## PLANNING COMMISSION AGENDA

1. Public Hearing and motion on the Special Use Permit for a Cell Tower to be located at 7235 W. Coldwater Road, Flushing, MI 48433, Parcel No. 08-24-200-036, pursuant to *Article XVIII Special Use Permits*
2. Motion on the Site Plan Review for a Cell Tower to be located at 7235 W. Coldwater Road, Flushing, MI 48433, Parcel No. 08-24-200-036, pursuant to *Article XVIII Site Plan*.
3. Discussion and possible motion on 2023 Planning Commission Report.

**RE: Verizon Wireless Zoning Application at 7235 Coldwater Road**

RE: Engineering Plan Review – 7235 Coldwater Road – Verizon Wireless Tower

**SITE PLAN**  
**DETAIL -**  
**NORTH**

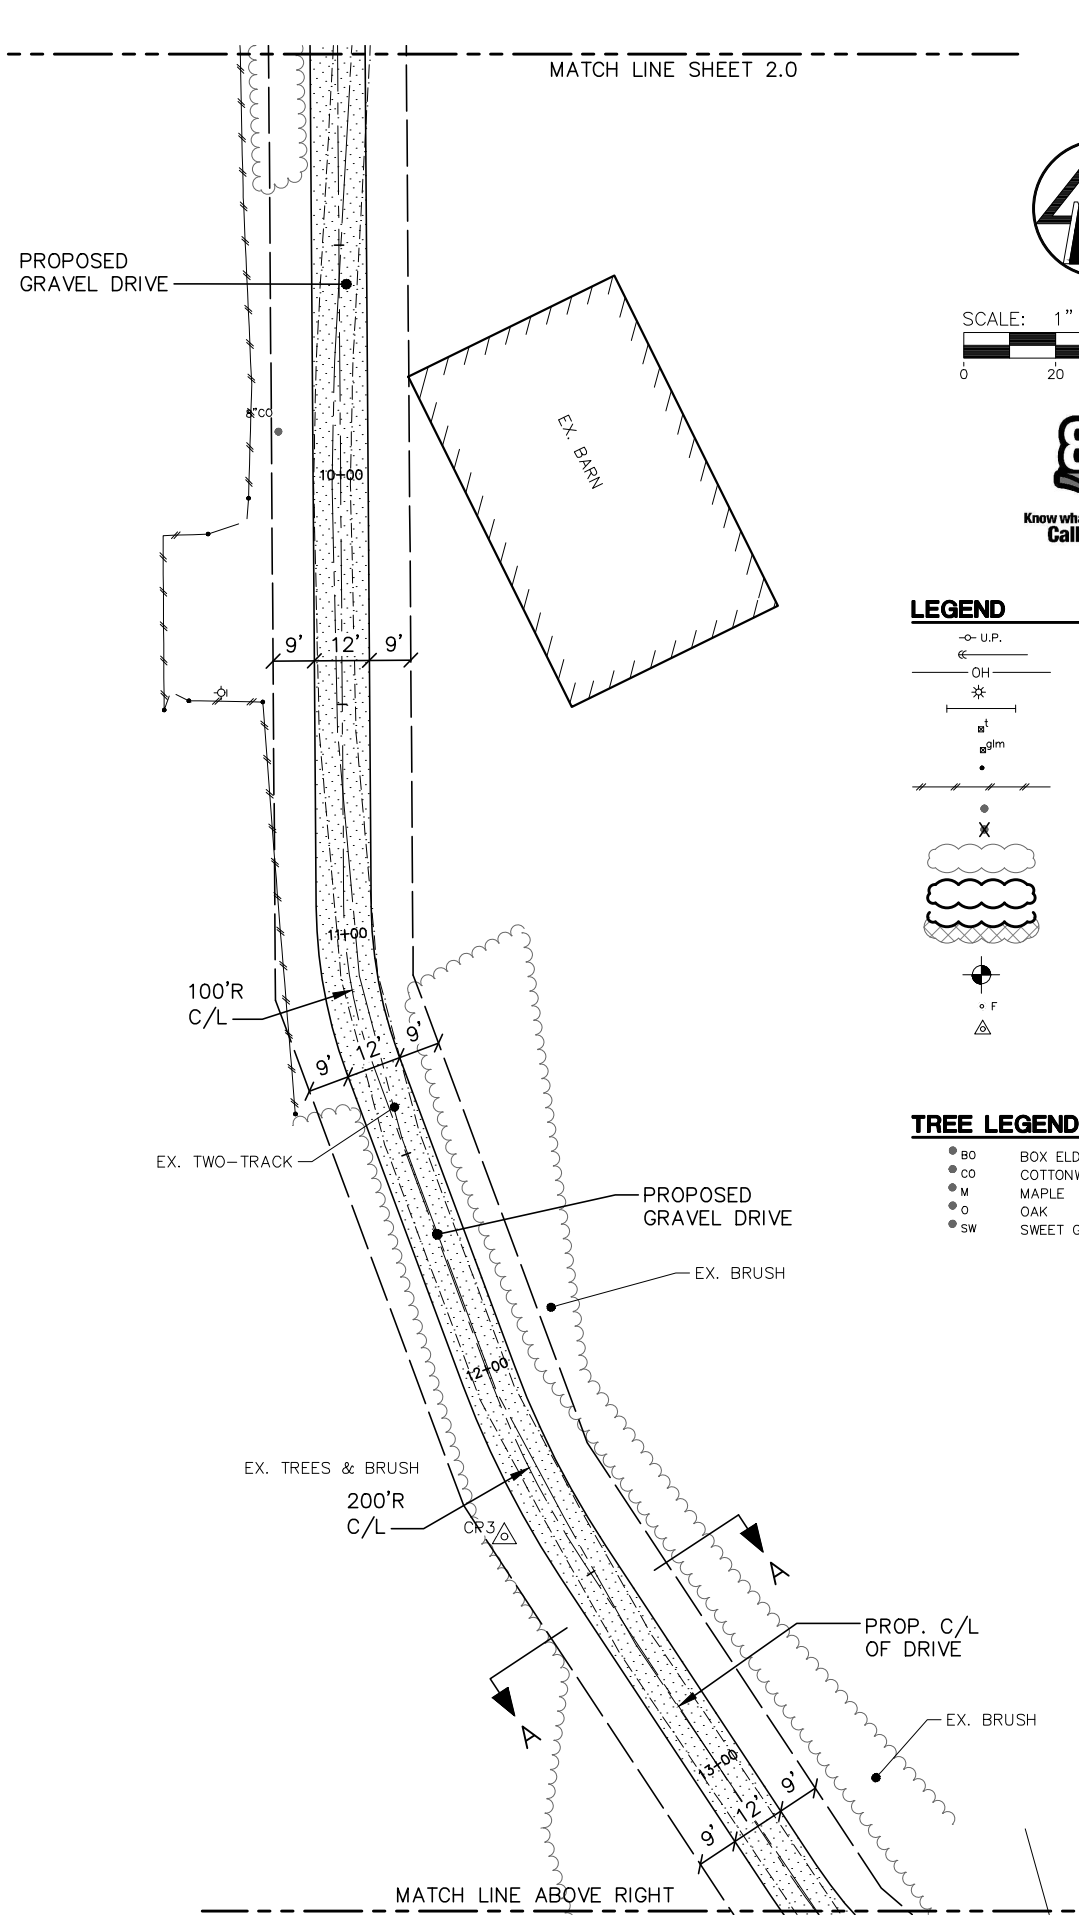
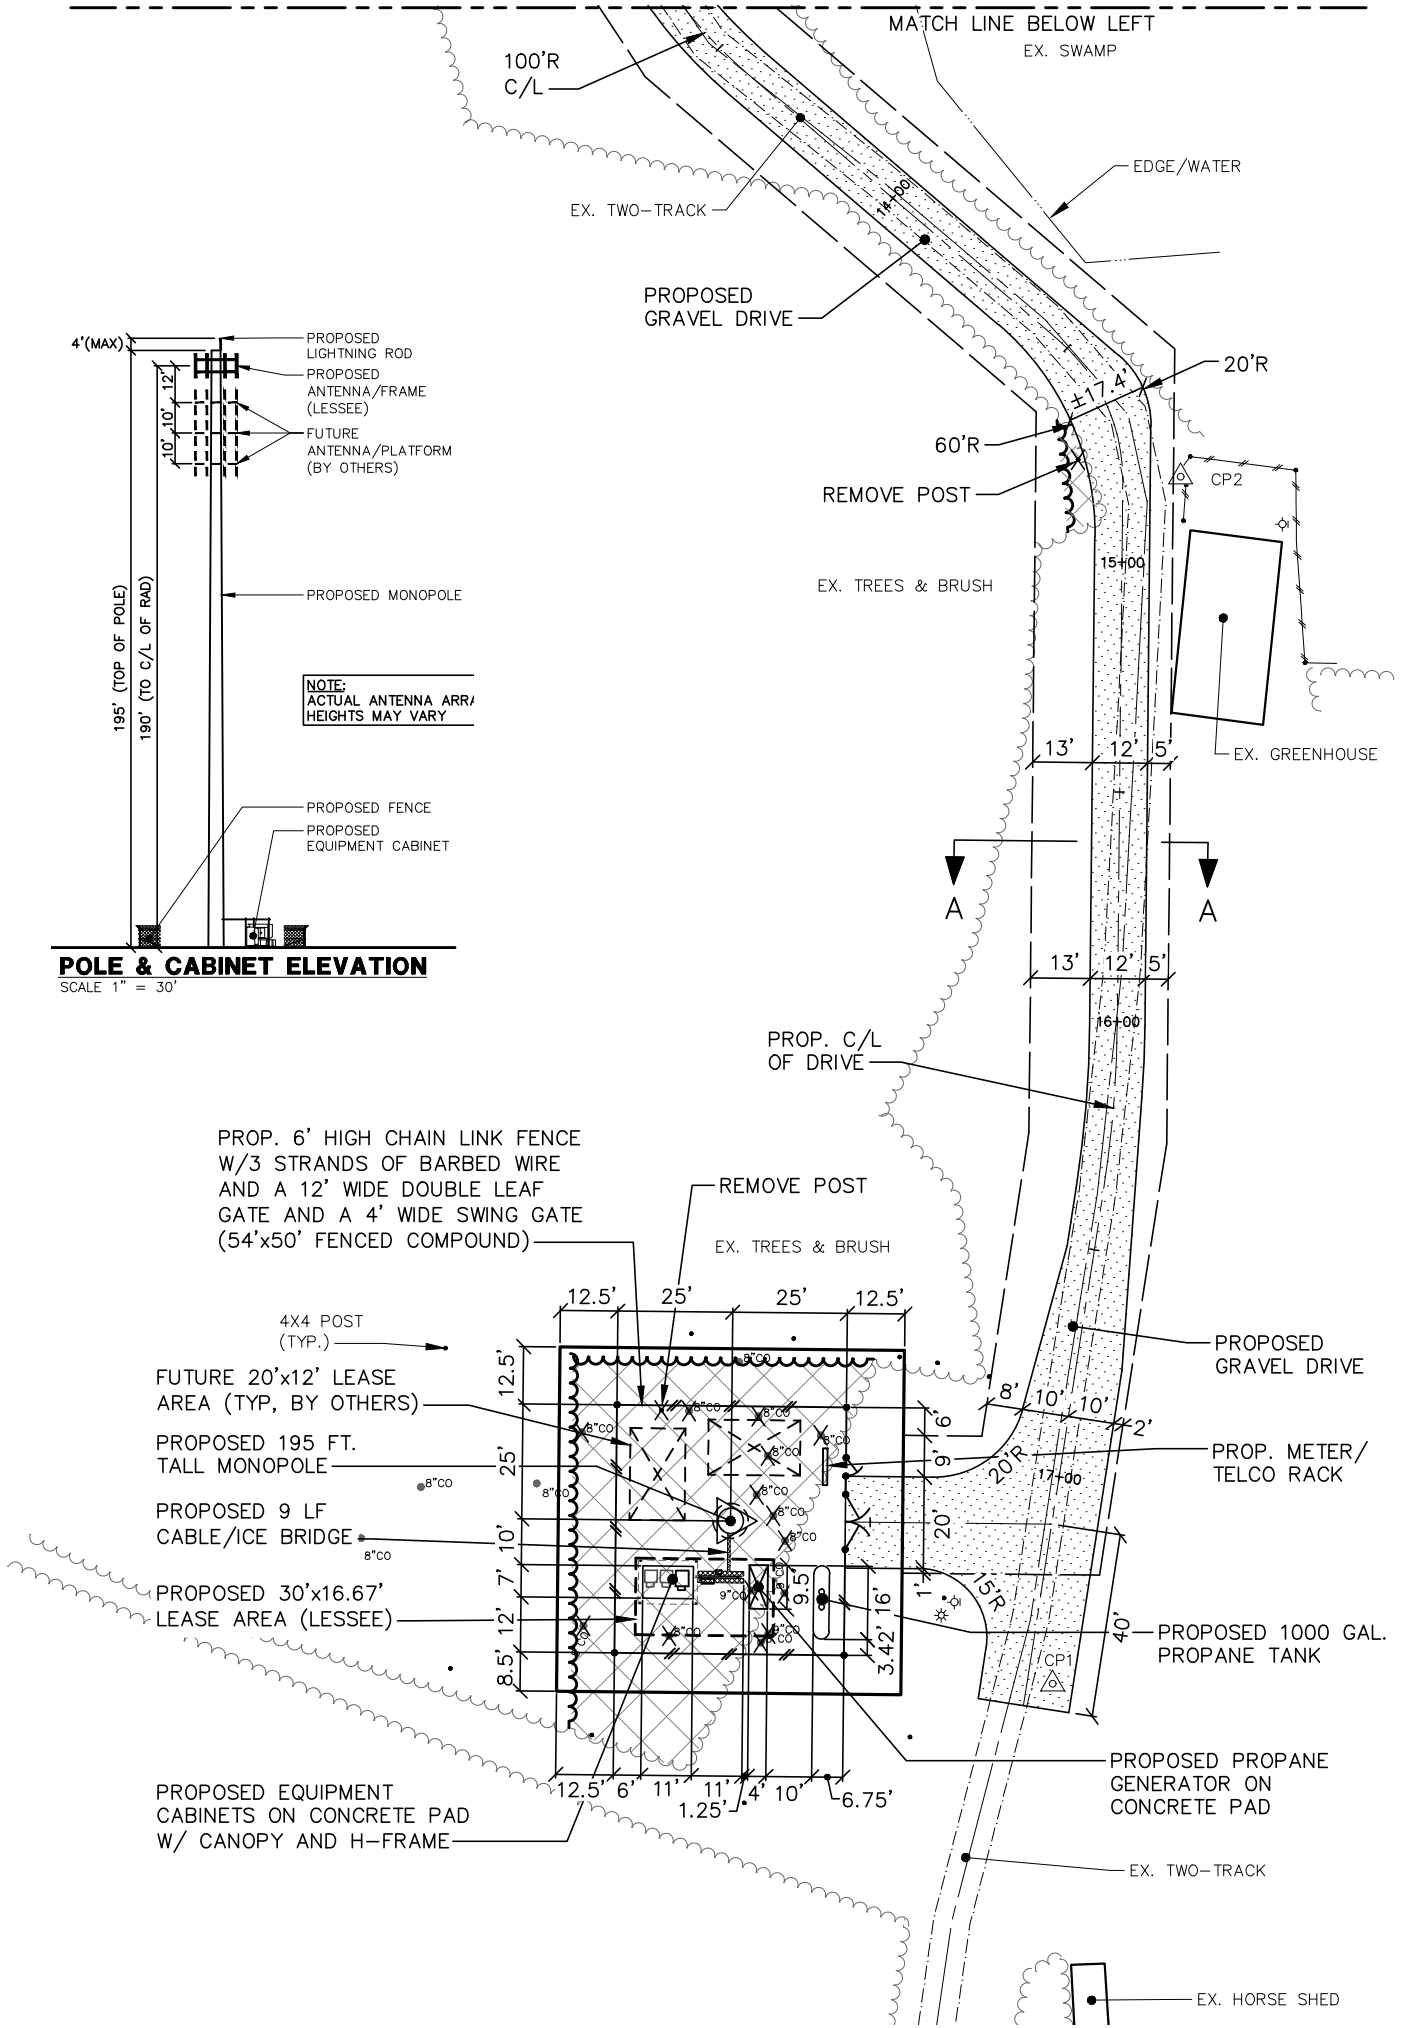
2. Sheet 2: A larger, fire code compliant “hammerhead”—or even a full turnaround—at the end of the gravel drive is suggested at a minimum for fire trucks, if ever needed. Though “General Notes, Item 8” states that maintenance vehicles will typically consist of van type vehicles, a turnaround may also benefit larger delivery trucks/semis if any larger items are needed, perhaps by future collocators.

- Before any building permit shall be issued, a site plan drawn to a scale of one (1) inch equals twenty (20) feet, and at least two (2) copies of this site plan shall be submitted to the township clerk. Such site plan shall contain the following information: **On sheet 2, the applicant provided drawings at 1 inch equal to 30 feet.**

**GRADING PLAN - NORTH**

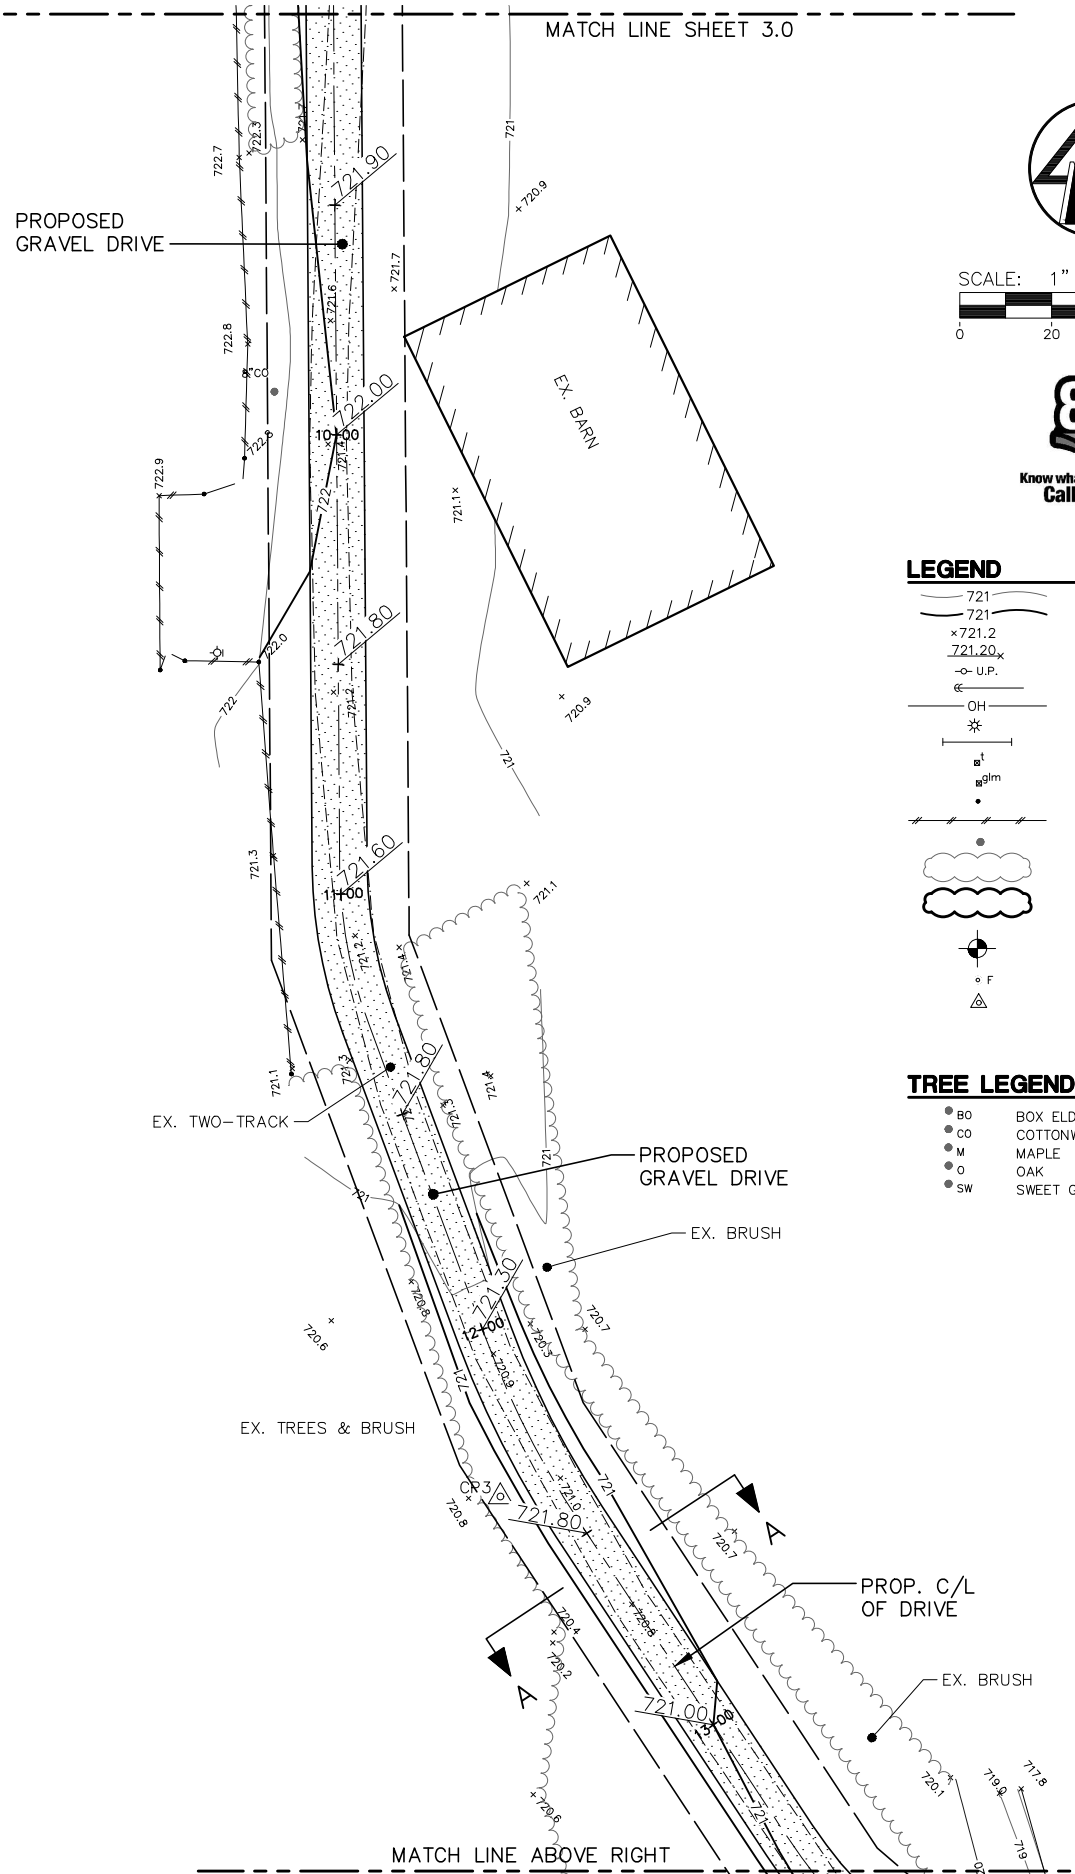
3. Sheet 3: The proposed gravel drive will abut an existing shed indicated near STA 7+60, with the drive falling towards the shed. No finished floor elevation is provided for the shed. Spot grades nearby would suggest that the finished floor should be high enough for no issues to arise. However, verifying the finished floor elevation of the shed is advised, as the proposed gravel drive will drain towards the shed.

NOTE:  
 CONTRACTOR SHALL GRADE  
 DRIVEWAY IN A MANNER TO  
 PREVENT RUNOFF FROM  
 DRAINING INTO SHED
